NEW HOTEL AND OFFICE/RETAIL BUILDINGS 600 S. SEPULVEDA BOULEVARD MASTER USE PERMIT

PLANNING COMMISSION NOVEMBER 18, 2020

RAMP AND VISIBILITY

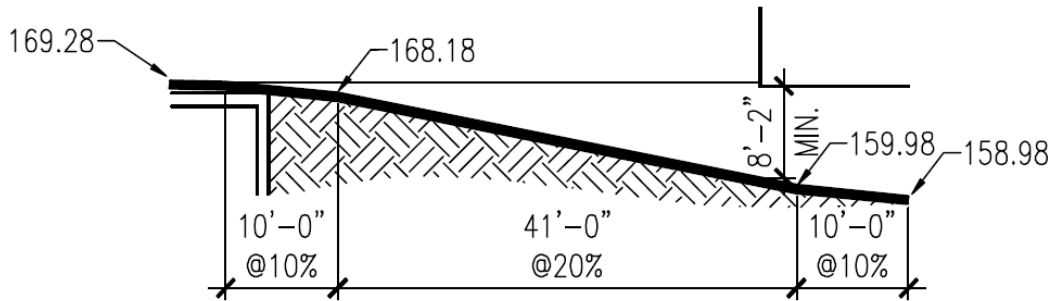
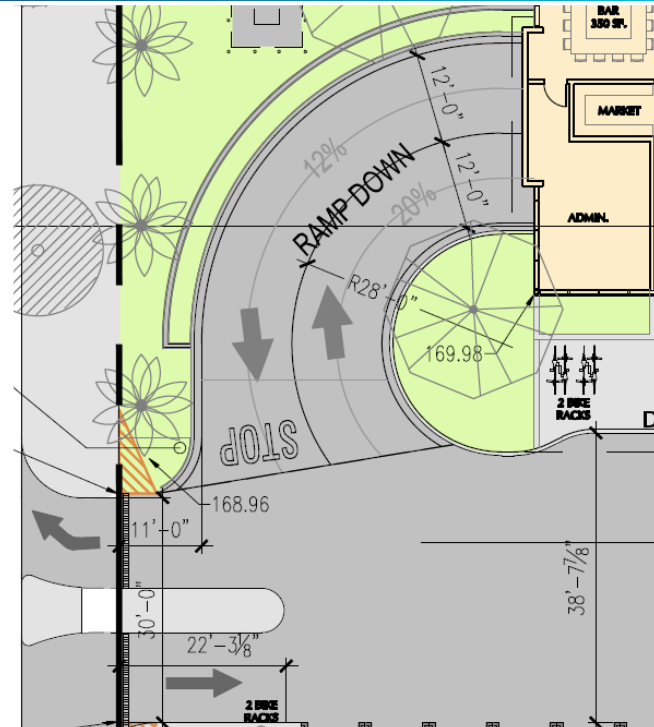
- Wider ramp
 - 24 feet with one-foot curb per side
- Top of Ramp
 - Flatter
 - Stop Sign
- Ramp farther from Sepulveda Blvd

LINE-OF-SIGHT/NEIGHBOR PRIVACY

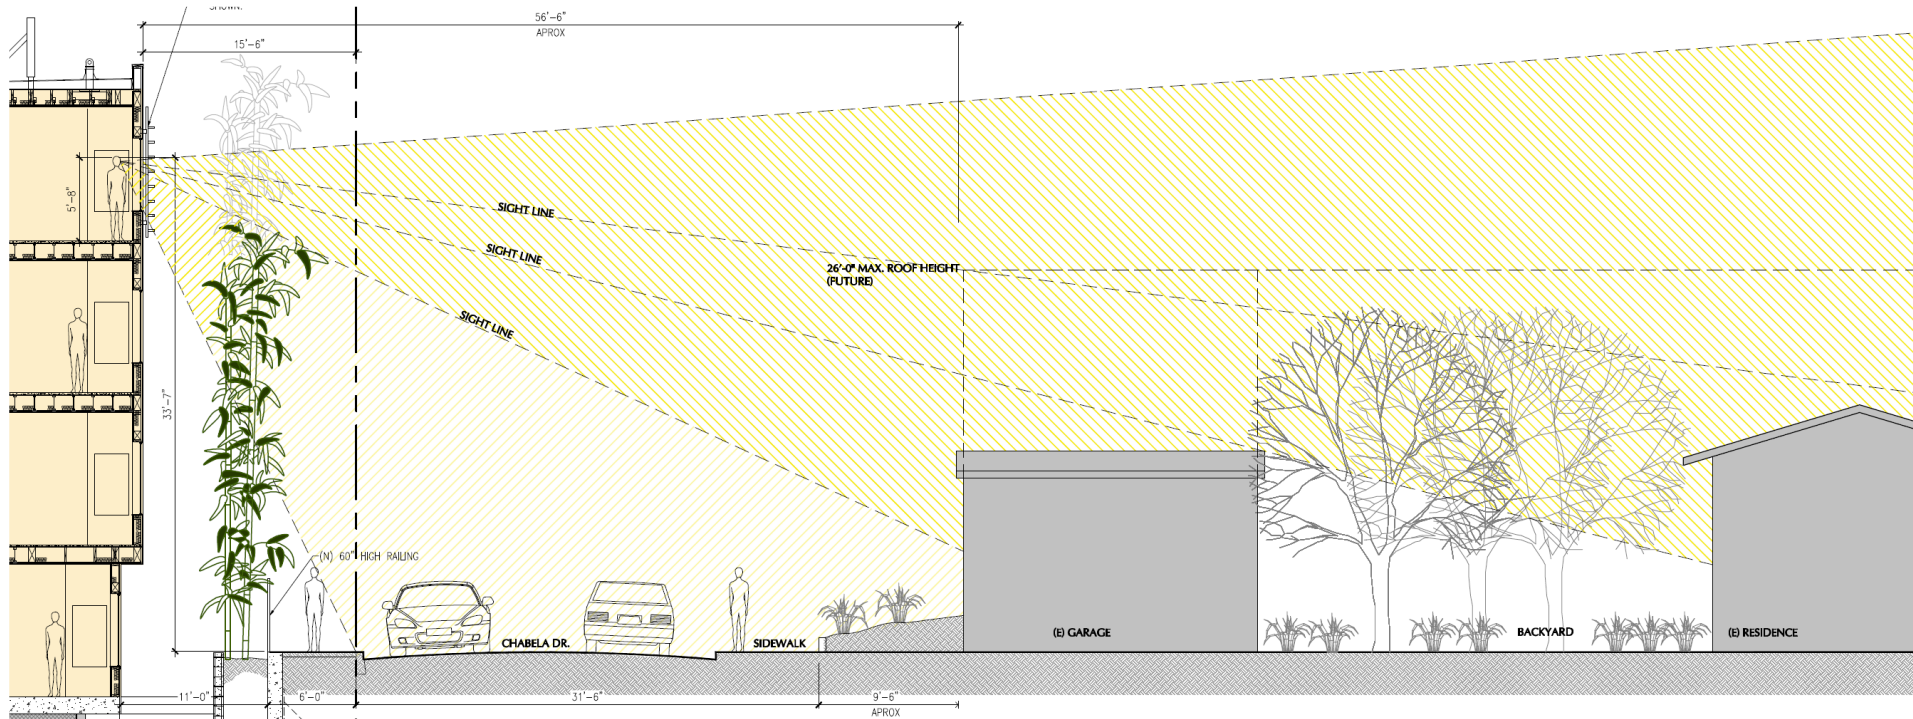
- Line-of-Sight Diagram: views into neighbors' back yards
 - Existing one-story homes along Chabela Drive
- Doesn't take into account effects of screens and bamboo
- Screens and bamboo provide a visual buffer between uses, although not required by Code

9/22 SUNSET: 6:50 P.M.
SEPTEMBER 22ND, 5:00PM

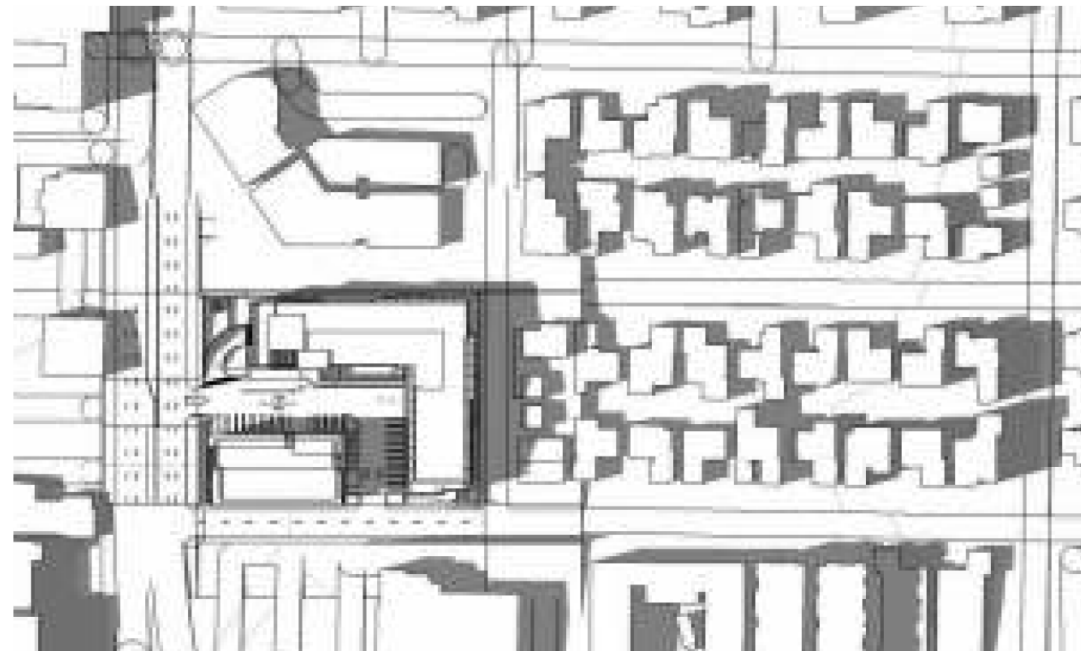
- First day of each season
- Morning (8:00 a.m. or 9:00 a.m.)
- Mid-day (12:00 p.m.)
- Evening (4:00 p.m. or 5:00 p.m.)
- Hotel building's evening shadow onto neighboring properties to the east
